**CALIFORNIA COASTAL COMMISSION**

**Item Th 19e****STAFF REPORT: REGULAR CALENDAR****APPLICATION NUMBER:** 5-01-018**APPLICANTS:** Robert and Nancy Conger**AGENT:** GWC Architects, Attn: Gerald Compton**PROJECT LOCATION:** 501 Paseo de la Playa, Torrance (Los Angeles County)

**PROJECT DESCRIPTION:** Interior remodel and construction of a 591 square foot, 12.5-foot high first story addition at the rear of an existing 3,152 square foot, two-story single family residence on the bluff top and construction of three retaining walls, a 404 square foot patio area with spa and stairs, and a 246 square foot wood deck cantilevered 12 inches above existing grade on the bluff face in the rear yard of a 23,400 square foot, R-1 zoned bluff lot. A total of 8.9 cubic yards of excavation and fill is required to install the spa and 34.8 cubic yards of excavation and fill is required for the patio, stairs and footings.

**SITE PLAN / GENERAL NOTES - DRAINAGE**

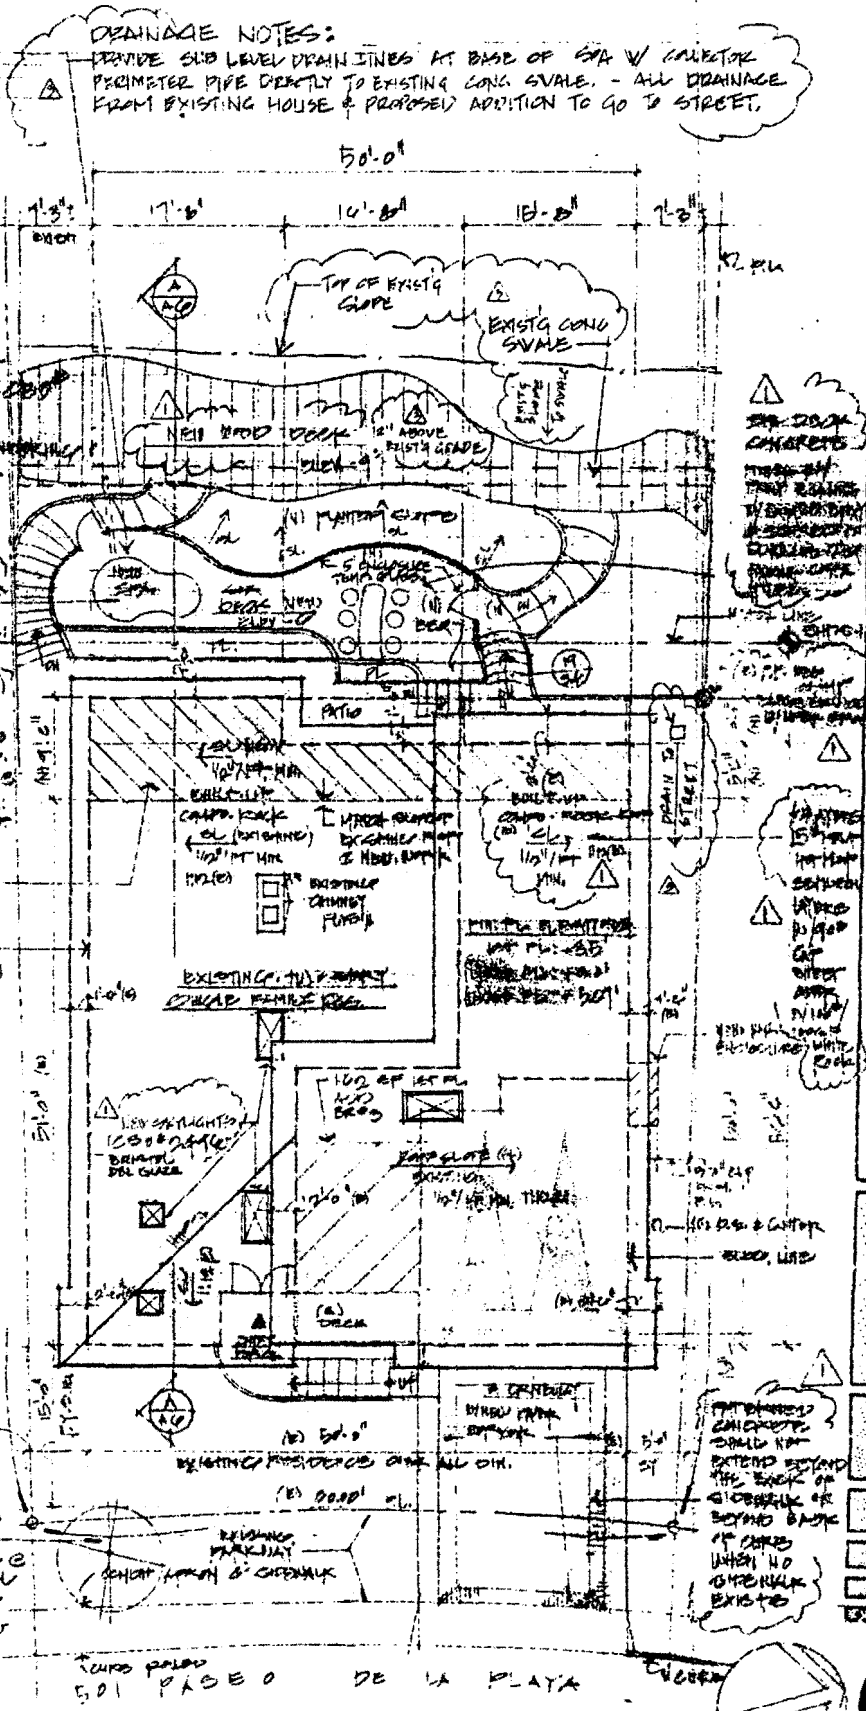
1. Show only development inland of the top of bluff on the plans and eliminate from plans all proposed development seaward of the top of bluff (shown in Exhibit #3).
  - (a) Show the proposed living room and family room addition inland of the top of bluff at the rear of the existing single family residence.
  - (b) Eliminate from plans the proposed patio area, spa, retaining walls, stairs and cantilevered wood deck.

- (c) Eliminate the previously revised plans, which incorporated Revision 3, Drainage Plan, for the proposed spa.
- B) The revised plans shall, prior to submittal to the Executive Director, be reviewed and certified by a qualified professional to ensure that they are consistent with the Commission's approval and with the recommendations of any required technical reports *[please see special condition 4]*.
- C) The permittee shall undertake development in accordance with the approved final plans. Any proposed changes to the approved final plans shall be reported to the Executive Director. No changes to the approved final plans shall occur without a Commission amendment to this coastal development permit unless the Executive Director determines that no amendment is required.

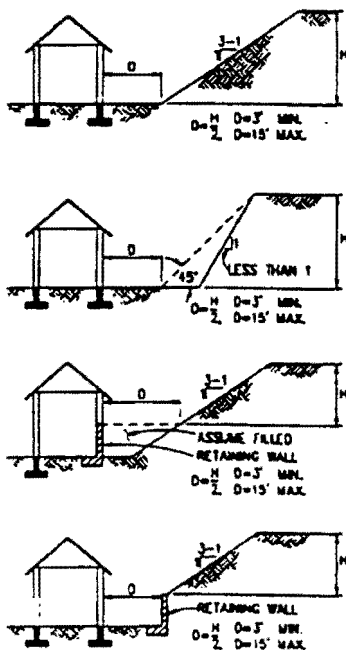
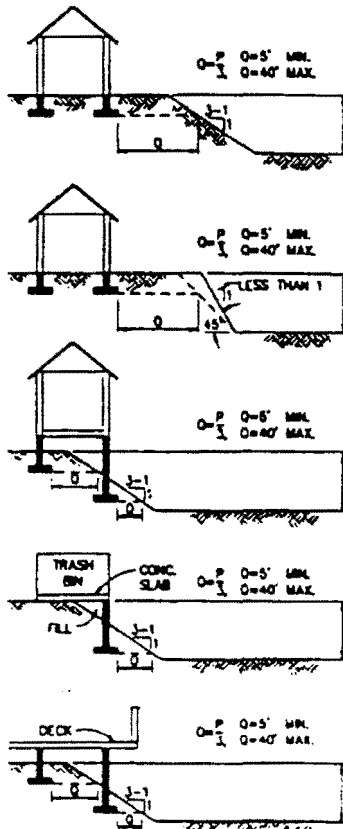
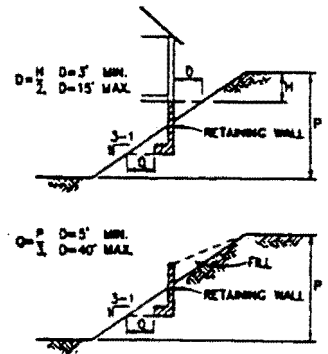
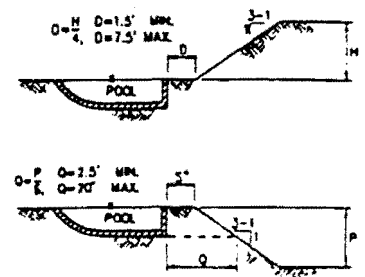
According to the geotechnical engineering report, the City of Torrance Zoning Code (which the Commission uses as guidance) states that a footing setback from steeper than 3:1 slope (lower edge of cut slope) is one-third the vertical height of the slope measured horizontally from the lower edge of cut slope to the footing (Exhibit #4, p.3). The report identified the lower edge of cut slope as the top of bluff. While the Commission's Senior Geologist disagrees with that characterization, he does agree that the development as proposed would be stable. In this case, the top of the steeper than 3:1 slope is the lower edge of cut slope, which is seaward of the top of bluff (Exhibits #3, p.2 and #5). The lower edge of cut slope, therefore, does not refer to the top of bluff in this situation. Since the vertical height to the lower edge of cut slope is 115 feet measured from the beach (as stated on page 1 of the Wave Impact Study report) (Exhibit #6, p.1), the City requires a 38-foot 4-inch setback for the footings from the lower edge of cut slope. The City required spa setback is one-half the building footing setback distance required above. Therefore, the City requires a 19-foot 2-inch setback for the spa from the lower edge of cut slope. The proposed project includes a 38-foot setback for the footings (measured at the center of the footing shown on Section A of Sheet 6 of the plans) (Exhibit #3, p.2) and a 25-foot 6-inch setback for the spa. The proposed footings and spa setbacks are substantially consistent with those required by the City. Special Condition 1 requires that the living room and family room addition and spa are built at the minimum required setbacks required by the City, either as described on the diagram in the geotechnical engineering

report shown on Exhibit #4, p.3, or as otherwise required by the City of Torrance Department of Building and Safety.

The lot on which development is proposed is a gently sloping parcel with an approximate angle of 26 degrees. The City requires a 38-foot 4-inch setback for the footings and a 19-foot 2-inch setback for the spa from the lower edge of cut slope, as is recommended in the geotechnical engineering report prepared for the proposed project. The Commission's Senior Engineer and Geologist reviewed the geology report, geotechnical engineering report and wave impact study report prepared for the site and determined that the minimum footings and spa setbacks from the lower edge of cut slope that are required by the City are adequate to ensure stability of the bluff under current conditions. The Commission finds in this particular case that the City's setback requirements for the footings and spa will not add to instability, but will add to a pattern of development extending onto the bluff face. Since bluff face development would require walls and pilings, such development would disturb the integrity of the sand bluff face. Allowing additional development on the bluff face would add to a cumulatively unstable pattern along this stretch of the bluff. The Commission finds that the living room and family room addition, which is located inland of the top of bluff, as conditioned to be built at the minimum setbacks required by the City, minimizes risks to life and property, assures stability and structural integrity, does not create or contribute significantly to geologic stability or destruction of the site and surrounding area. Only as conditioned to be setback from the lower edge of cut slope the distance required to minimize risks to life and property, assure stability and structural integrity of the structures, and neither create nor contribute significantly to geologic instability is the proposed addition consistent with Section 30253 of the Coastal Act.
